Item # 11
MCPB 10/23/03

MEMORANDUM

REVIEW TYPE: Site Plan Review
APPLYING FOR: C-1 Zone; 2.04 Acres Property
14, 000 sf of Commercial Retail and 3, 200 sf bank, including drive-in
PROJECT NAME: Colesville Eckerd Drug Store #6328
CASE #: 8-02032A
REVIEW BASIS: Site Plan Review Required in the C-1 Zone, Article 59-C-341.2
Site Plan Review Required for commercial properties adjacent to
residentially zoned properties, Zoning Regulations 59-E-2.81

SITE & GRADING PLAN

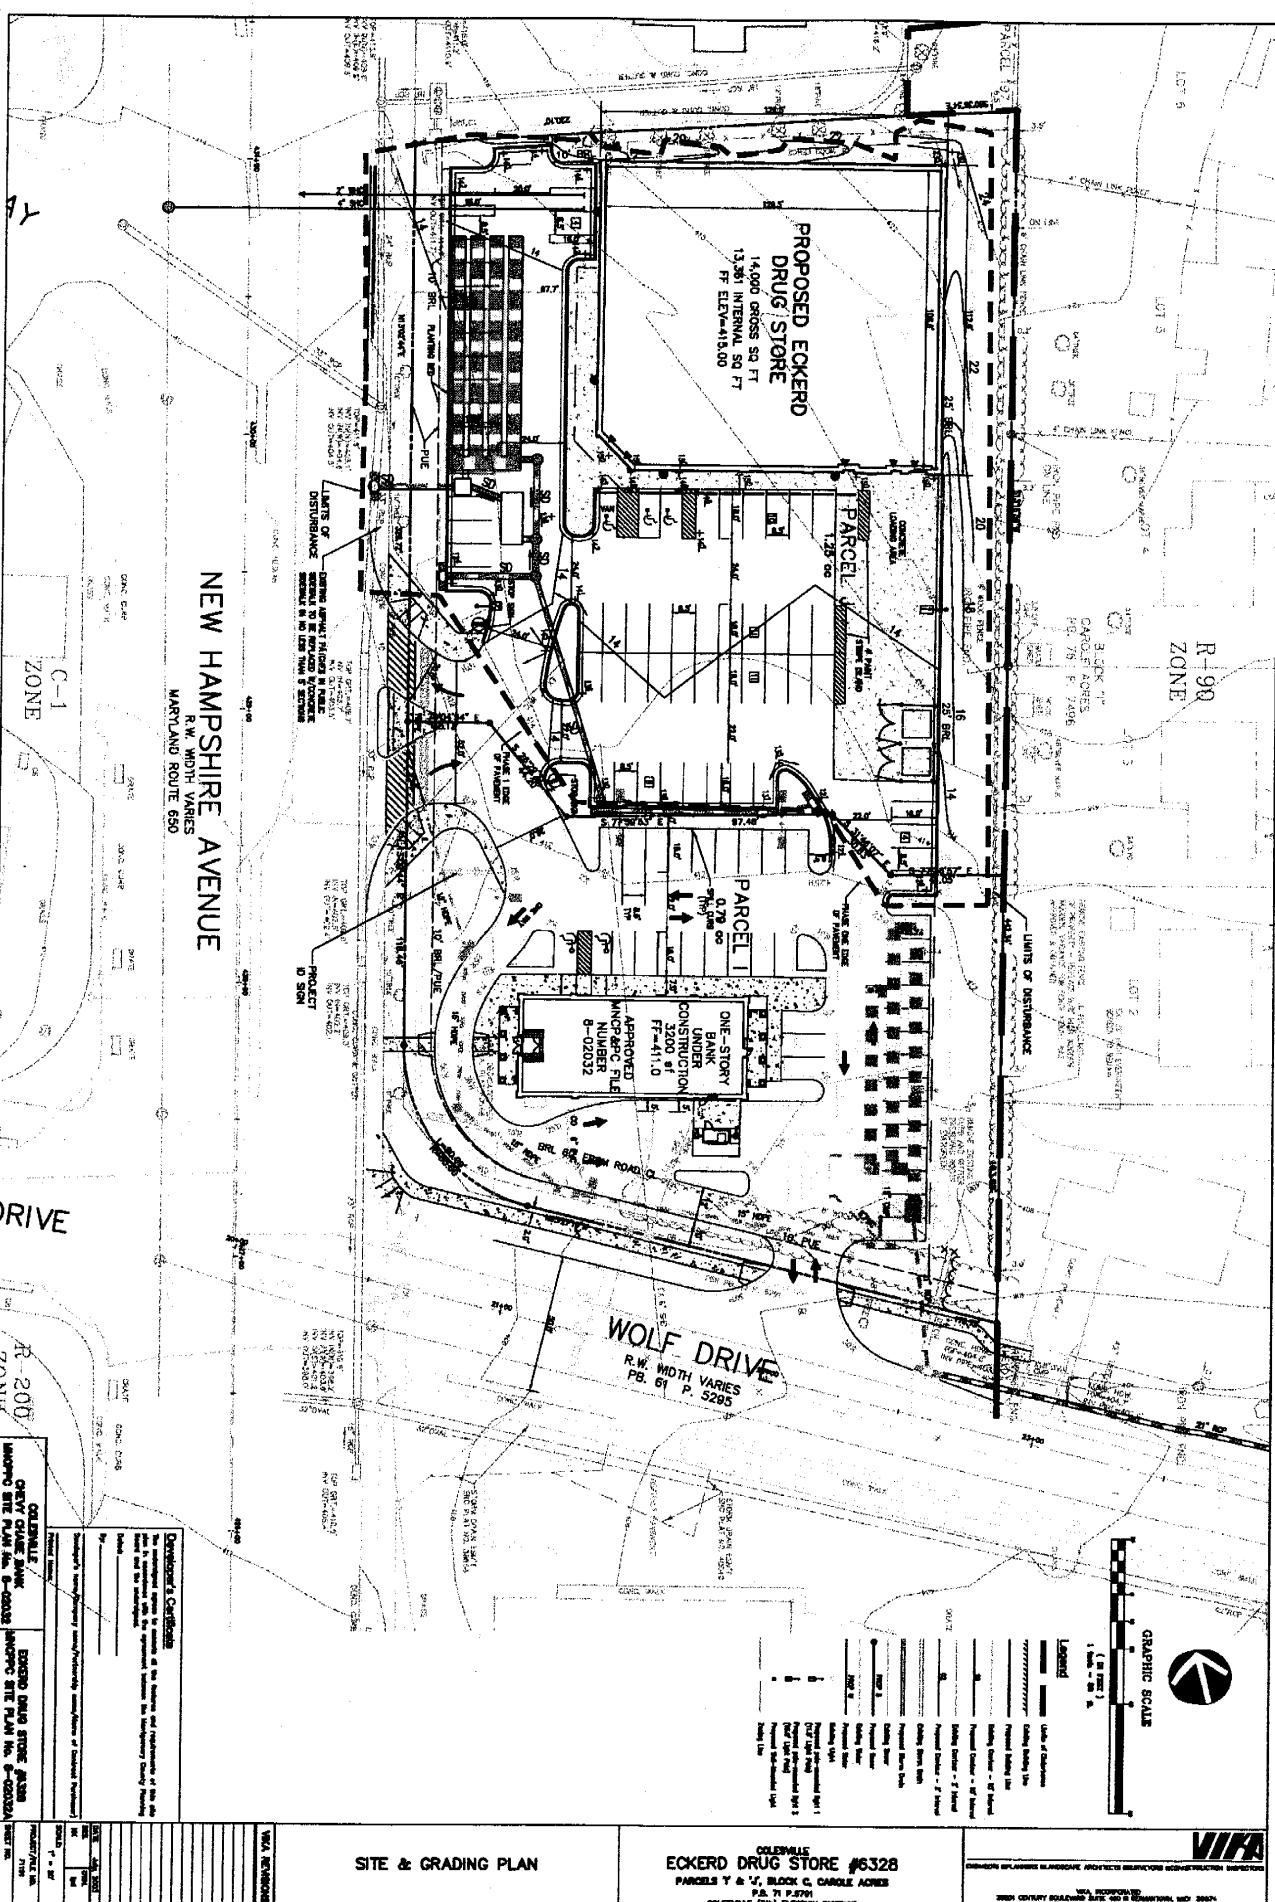
- d. Identify and label the existing 6-foot bike path (PB-24, Class III) along New Hampshire Avenue. Replace the asphalt patches with concrete sections, minimum 5-foot sections;

- e. Provide a parking facilities plan for the Phase I and II developments identifying the parking spaces allocated for the bank;
- f. Provide details of the dumpster enclosure. Enclosure to be similar in material to the façade of the proposed building;

- g. Provide an additional striped island for the parking space located with the concrete pad at the southeastern end of the building;
- h. Landscape and Lighting Plan to show the following:

- iv. Light poles not to exceed 18 feet in height, except on the eastern boundary, adjacent to the residential neighborhood, which shall not exceed 14 feet in height;

- v. All light fixtures shall be full cut-off fixtures;
 - vi. Deflectors to be installed on all fixtures causing potential glare or excess illumination, specifically on the adjacent residential property to the east;

- vii. Illumination levels not to exceed 0.5 footcandles (fc) at any property line abutting a residential zone;

LANDSCAPE/ FOREST CONSERVATION PLAN

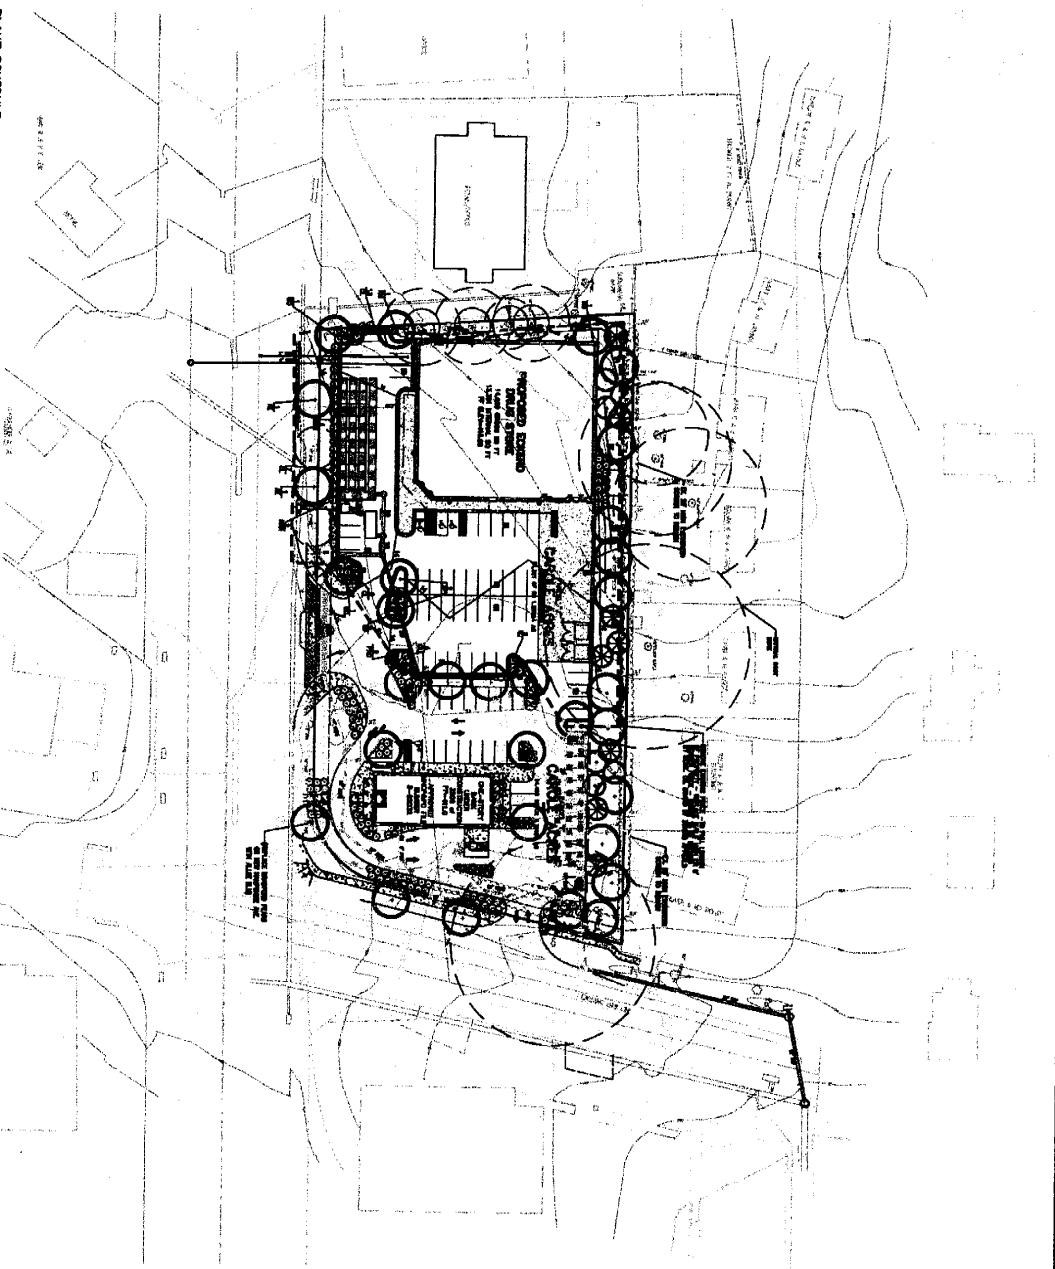
- i. Provide a lighting distribution plan showing details and specifications for lighting fixtures (fixtures, cut sheets, wattage, illumination summary, pole height, deflector shields); lighting levels shall follow the Illuminating Engineering Society of North America (IESNA), Lighting for Parking Facilities, RP-20-98, which recommends that light levels in parking lots where enhanced security is desired, not exceed a 15:1 Maximum to Minimum Uniformity Ratio;

- ii. Distribution Plan to include any wall pack or wall mounted fixtures on the proposed building;
 - iii. Distribution Plan to include safety lighting methods to address after-hour lighting distribution;
